# Access Compliance Report

## Public Rights-of-Way

Intersection ID: 29984	Main Street: CORBETT_SQUARE_LN	Cross Street: OLD_CAROLINA_DR	Location: NE
ADA ID: 4B72E955917E	Ramp Type: PerpDiag	Initial Pass/Fail: Fail	Overall Compliance: No
Codes/Mitigation Info/Possible Solution		Field Measurements/Component Compliance	
Severity Score: 46.25

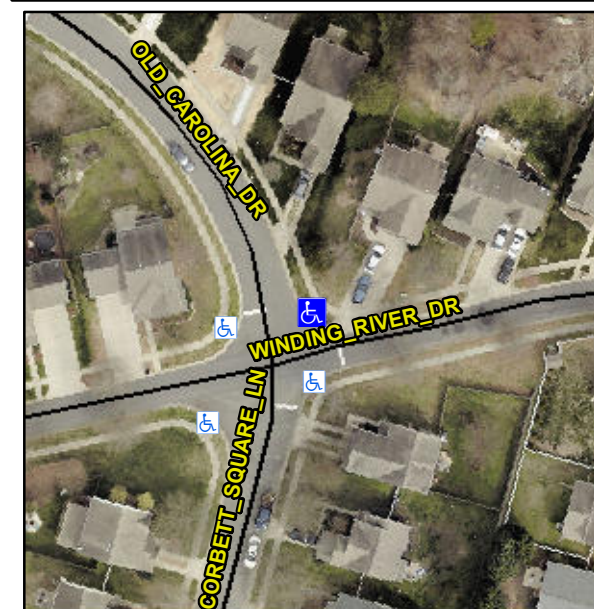
**Remove & Replace Curb Ramp With Two New Directional Ramps or Equivalent.**

**Not Found, R304.5.1, R304.2.2, R304.5.3**

Compliance	Description	Data	Compliance	Description	Data
N/A	Ramp Length (in)	72.0	No	Ramp Slope (%)	8.4
No	Ramp Width (in)	46.0	No	Ramp XSlope (%)	12.2
N/A	Flare Type LT	N/A	N/A	Flare Type RT	N/A
N/A	Flare Slope LT (%)	N/A	N/A	Flare Slope RT (%)	N/A
N/A	Flare Traversable LT?	N/A	N/A	Flare Traversable RT?	N/A
N/A	Landing Length (in)	N/A	N/A	DWS Provided?	N/A
N/A	Landing Width (in)	N/A	N/A	DWS Contrast?	N/A
N/A	Landing Slope (%)	N/A	N/A	DWS Length (in)	N/A
N/A	Landing X Slope (%)	N/A	N/A	DWS Full Width?	N/A
N/A	Landing Curb? (Y/N)	N/A	N/A	DWS Offset (in)	N/A
N/A	Shared Landing?	N/A			
N/A	Gutter Ponding?	N/A	N/A	Gutter Slope (%)	N/A
N/A	Gutter Lip Ht (in)	N/A	N/A	Gutter X Slope (%)	N/A
N/A	Painted X Walk1?	No	N/A	Painted X Walk2?	No
	X Walk 1 Direction	To W		X Walk 2 Direction	To S
N/A	X Walk 1 Width (in)	N/A	N/A	X Walk 2 Width (in)	N/A
	X Walk 1 Slope (%)	5.8		X Walk 2 Slope (%)	1.6
	X Walk 1 X Slope (%)	4.2		X Walk 2 X Slope (%)	8.8

N/A	Ramp inside XWalk1?	N/A	N/A	Ramp inside XWalk2?	N/A
	Road Slope (%)	9.7	N/A	Clear Space?	N/A
	Road X Slope (%)	1.3	N/A	Clear Space to XWalk (in)	N/A
N/A	Any Obstructions?	N/A	N/A	Storm Grate/Utility Hazard?	N/A
	Obstruction Type			Storm Grate/Utility Type	
		N/A			N/A
			Yes	Surface Condition? (G/P)	Good
